**KNOXVILLE HISTORIC ZONING COMMISSION
STAFF REPORT - CERTIFICATE OF APPROPRIATENESS APPLICATION**

PROPERTY ADDRESS: 227 Leonard PI 37917

FILE NO.: 8-F-15-HZ

AFTER-THE-FACT-REQUEST of 3/17/2016 POSTPONED to 4/21/2016 to explore mitigation options mainly to reduce size of gable-roofed frame addition projecting from the rear roof. The proposal is to reduce the width of the dormer by 24 inches by removing the roof overhangs on each side of the addition.

227 Leonard Place – Front façade – in progress – rear roof addition is barely visible.

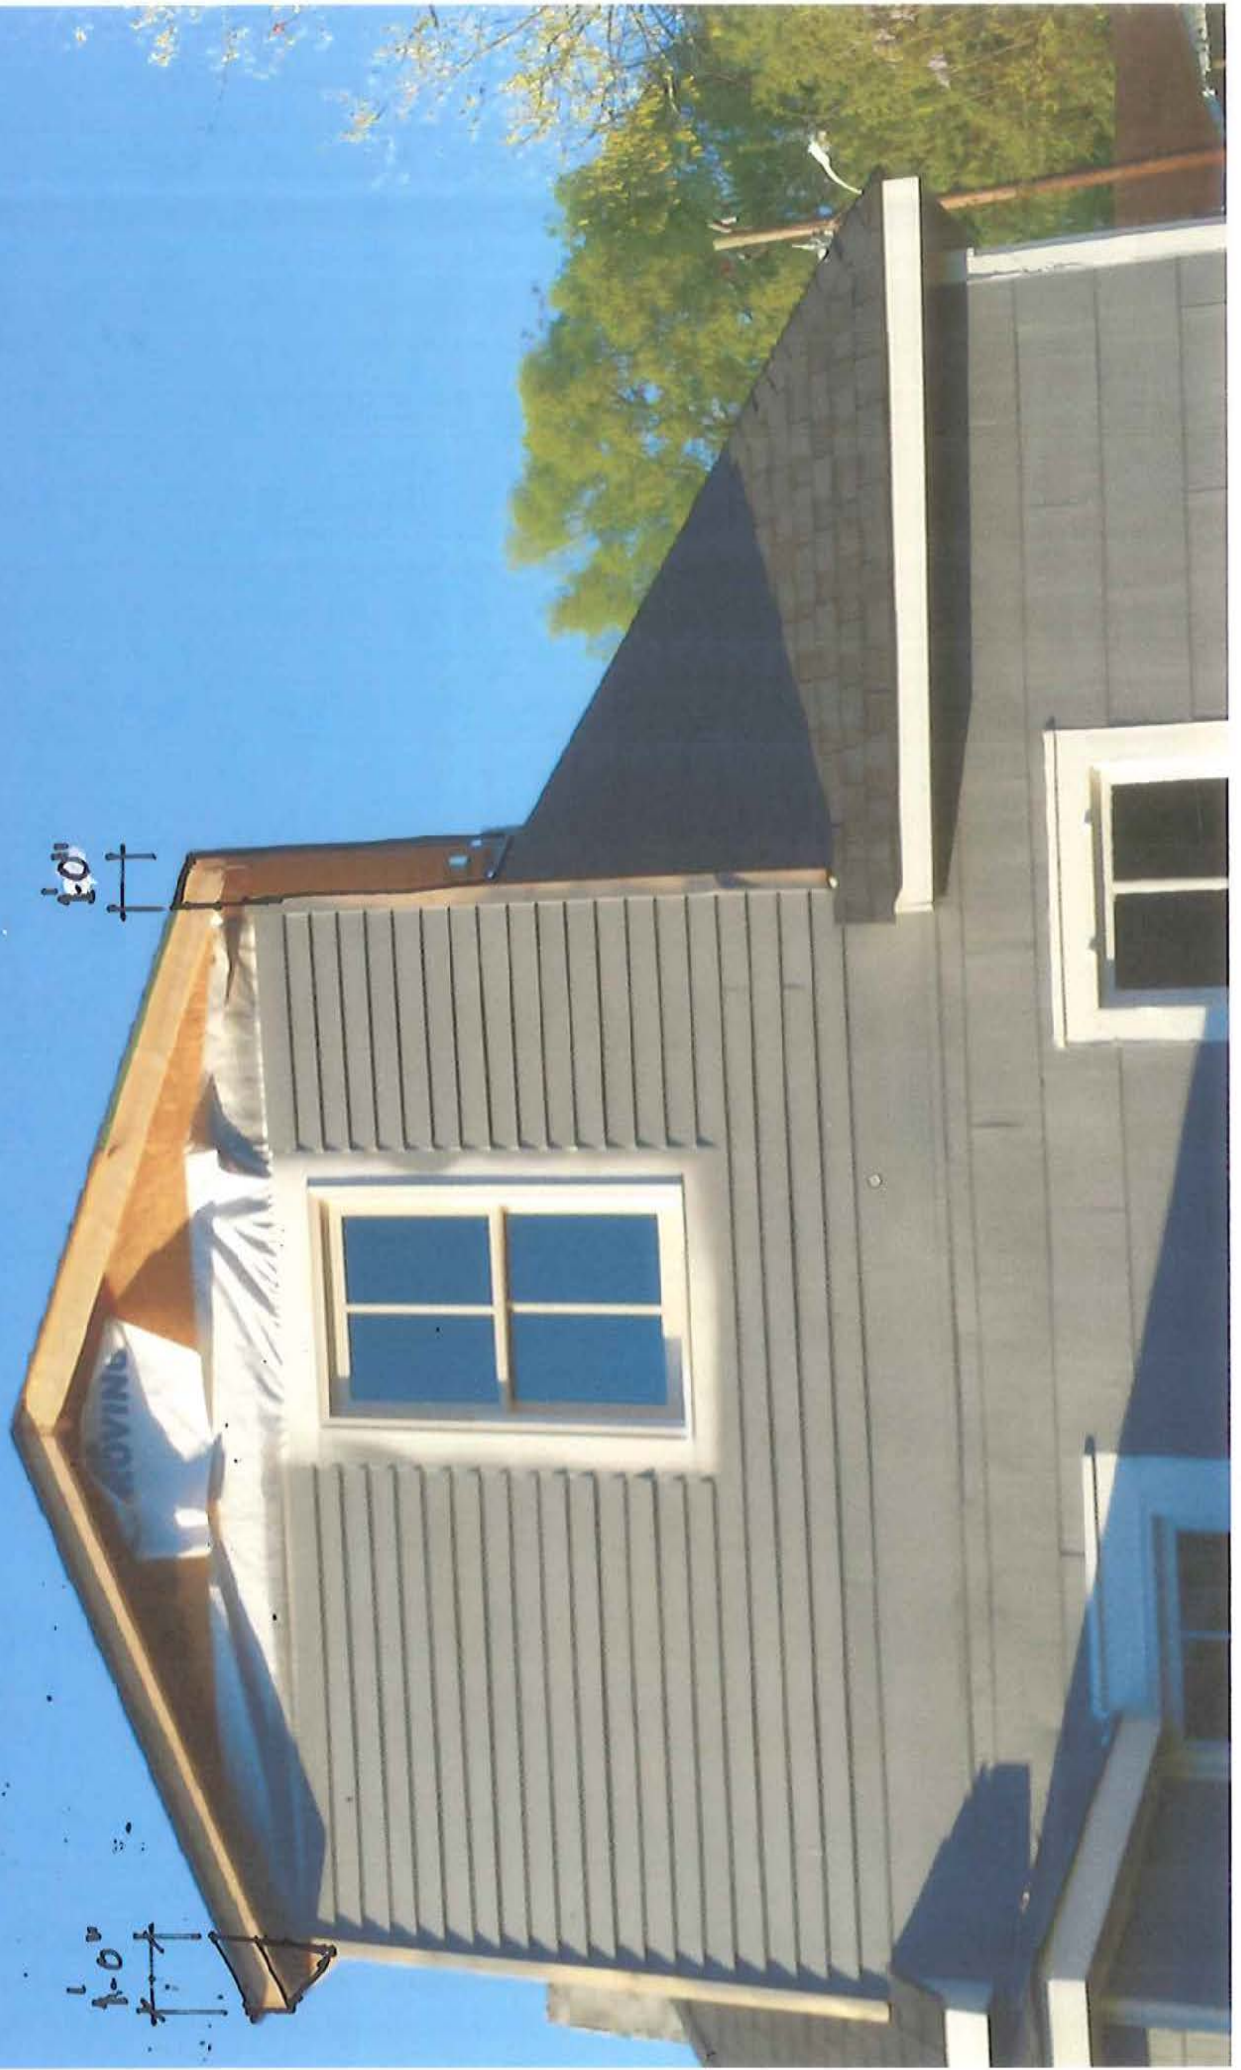
The proposed removal of the addition's roof overhangs to reduce the width by 24" is the only mitigation that can be made without removing the entire addition. The HZC will need to determine if the elimination of the visibility of the addition from the front of the house and from the west is sufficient to mitigate the most major concerns.

227 LEONARD PLACE
REAR ROOF ADDITION MODIFICATIONS
4.19.2016

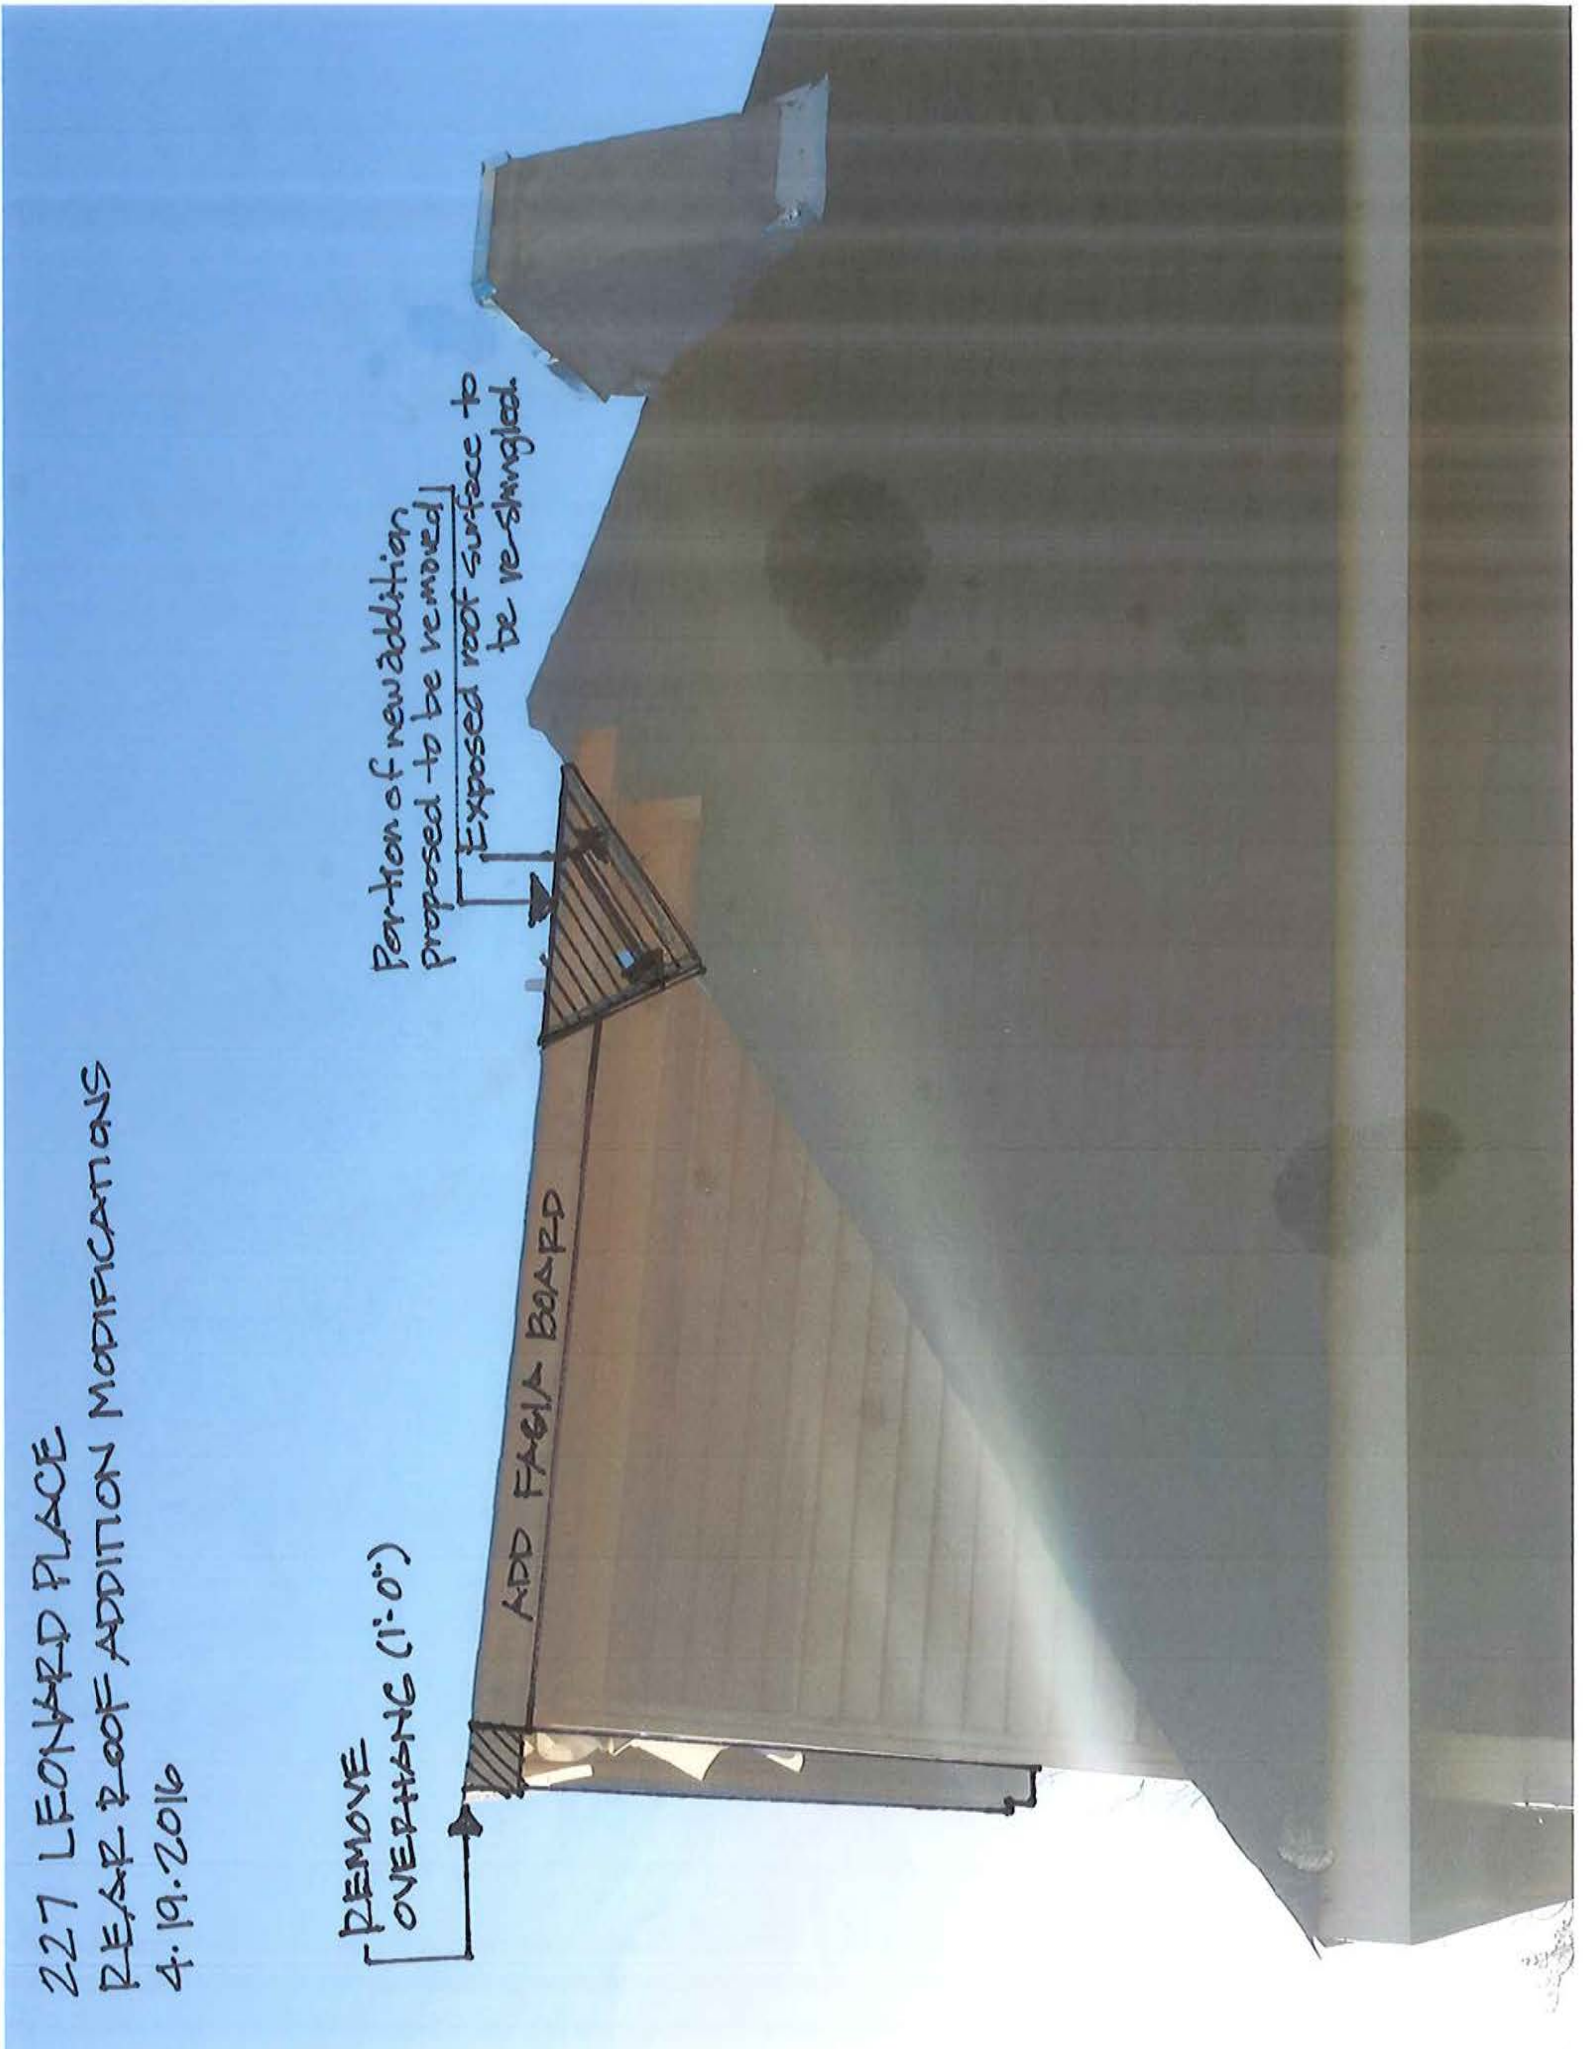
REMOVE
OVERHANG (1'-0")

ADD FASIA BOARD

Portion of new addition
proposed to be removed
Exposed roof surface to
be resingled.

227 LEONARD PLACE
REAR ROOF ADDITION MODIFICATIONS
4/19/2016

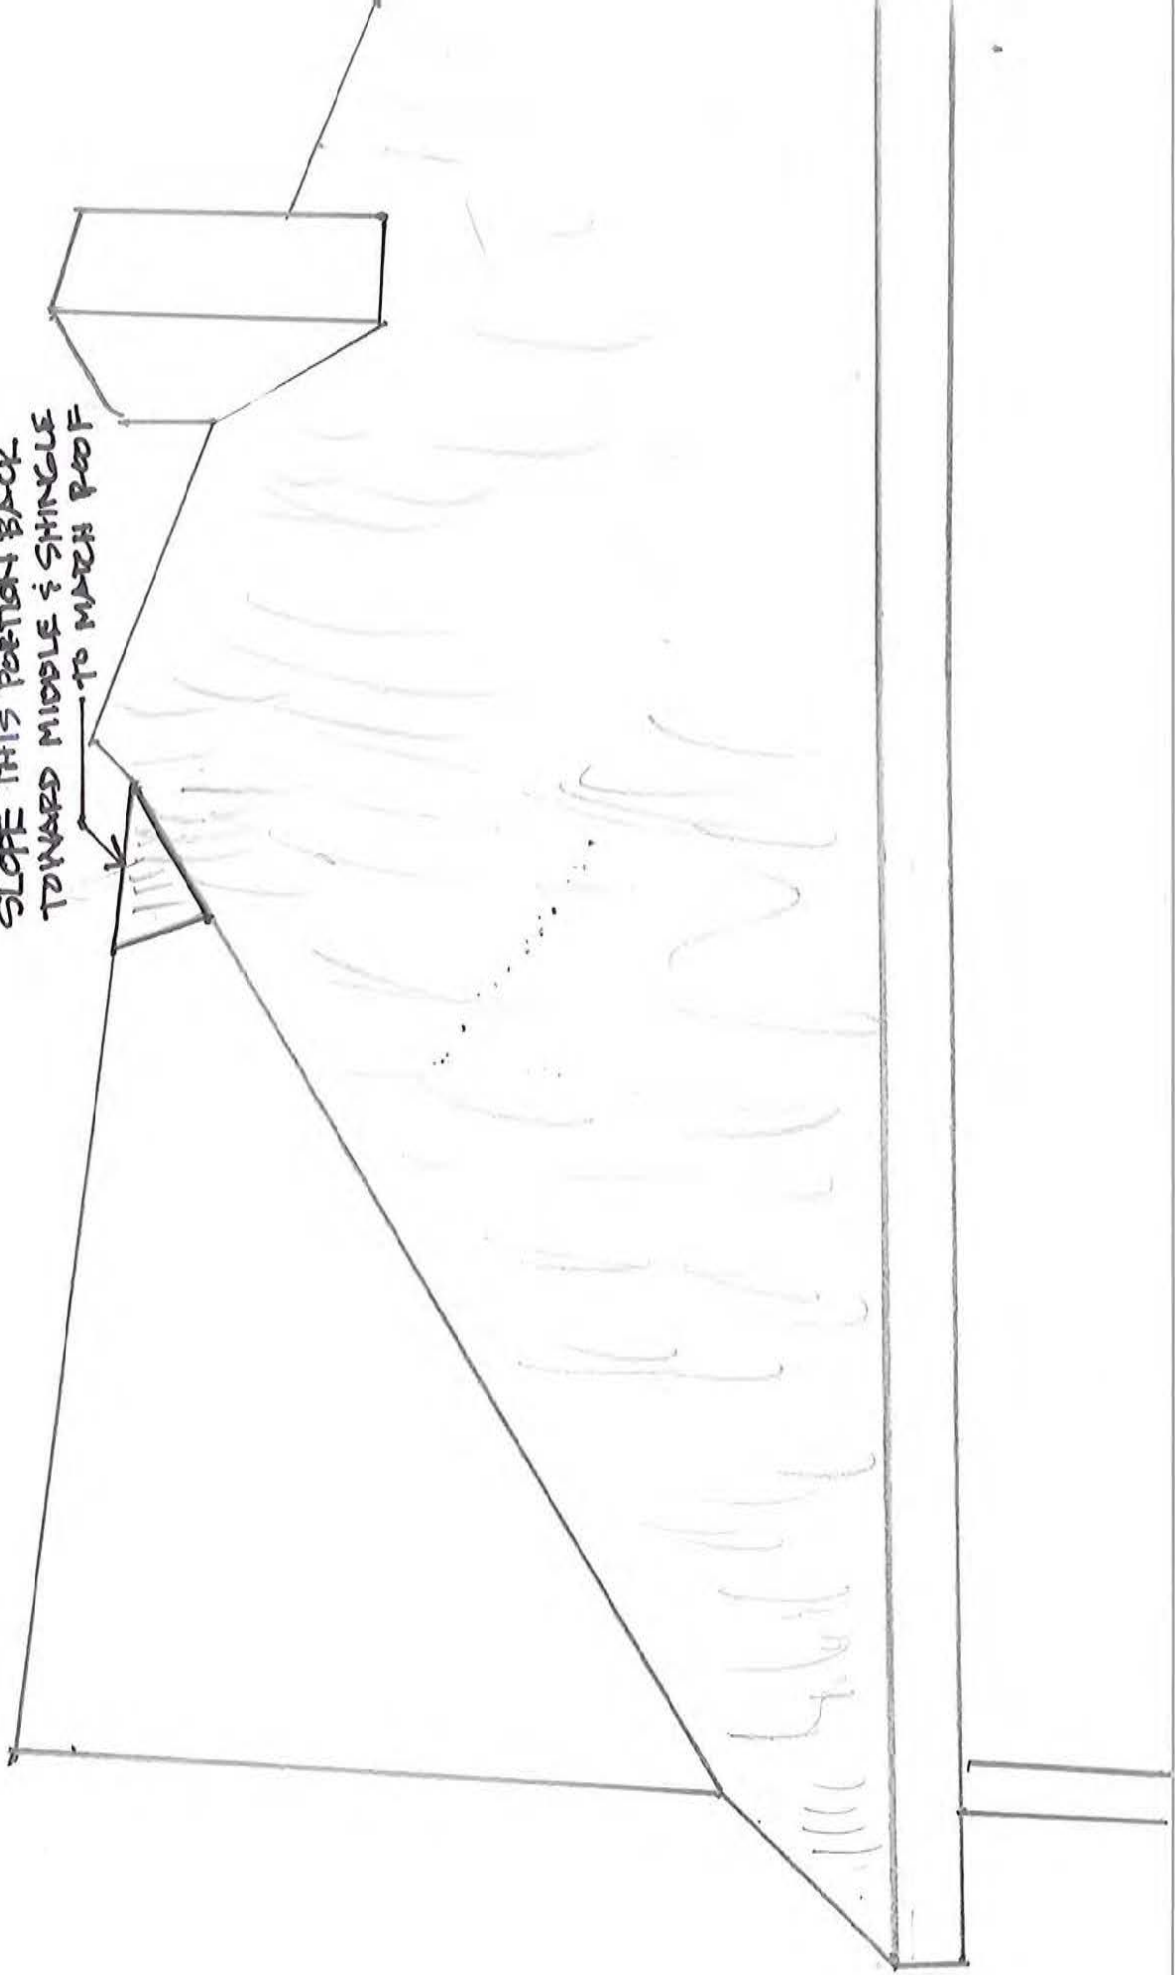
SLOPE THIS PORTION BACK
TOWARD MIDDLE & SHINGLE
TO MATCH ROOF

227 LEONARD PLACE
REAR ROOF ADDITION MODIFICATION
4.19.2016

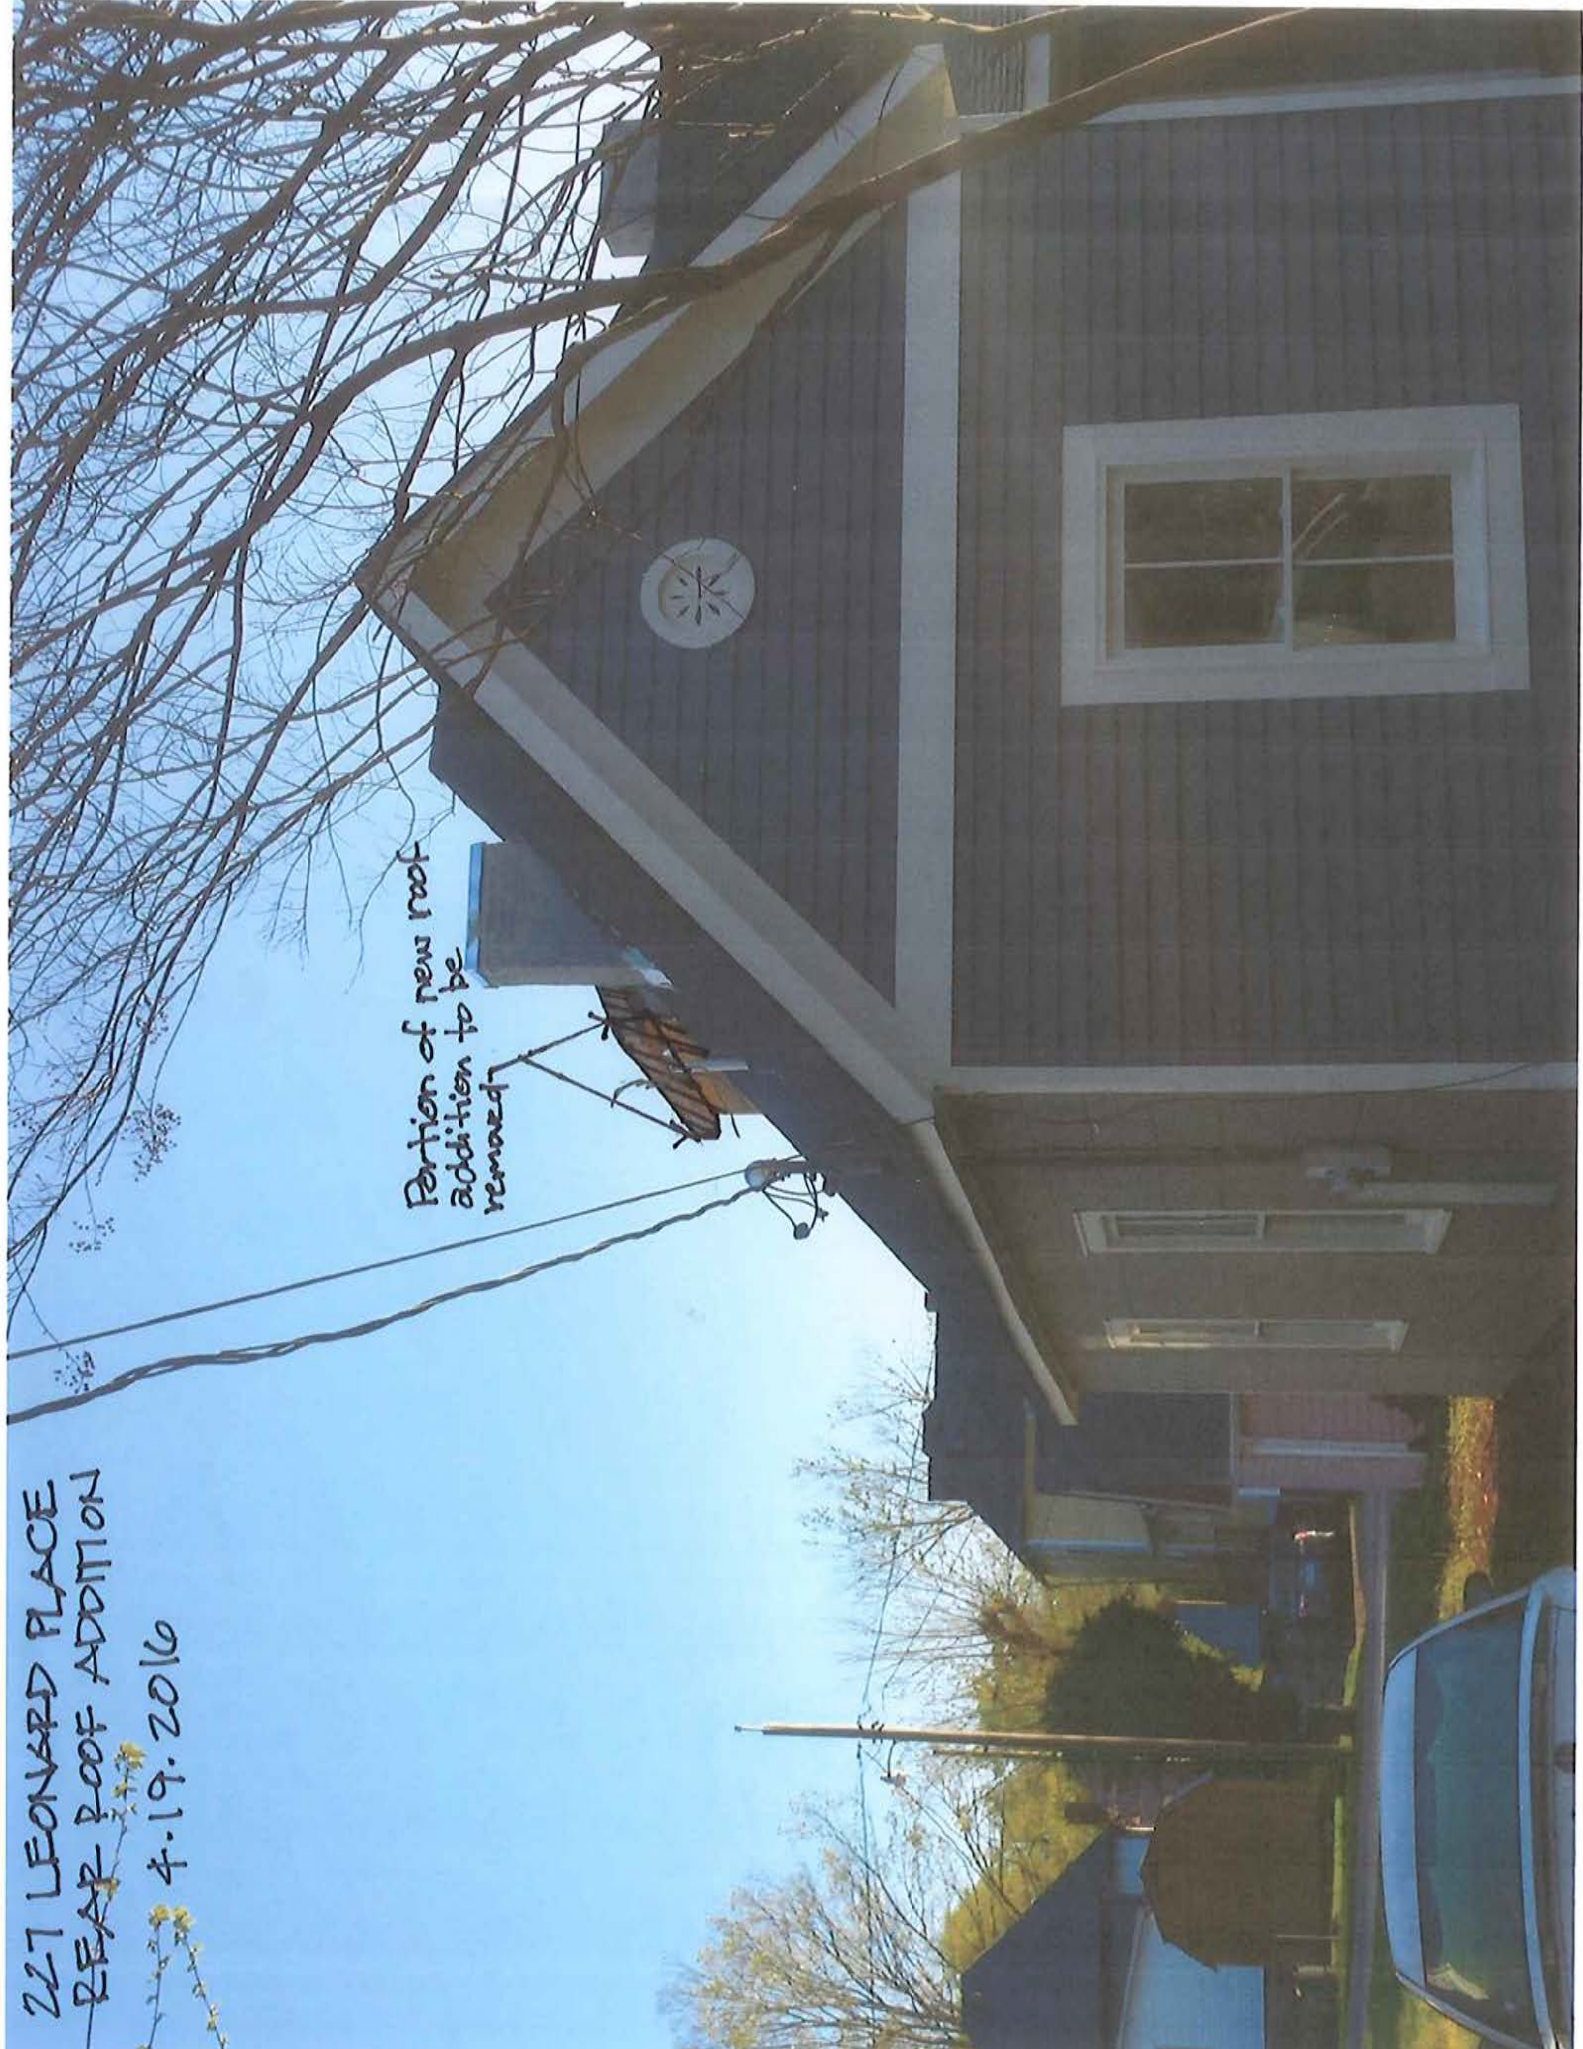
Portion of new roof
addition to be
removed
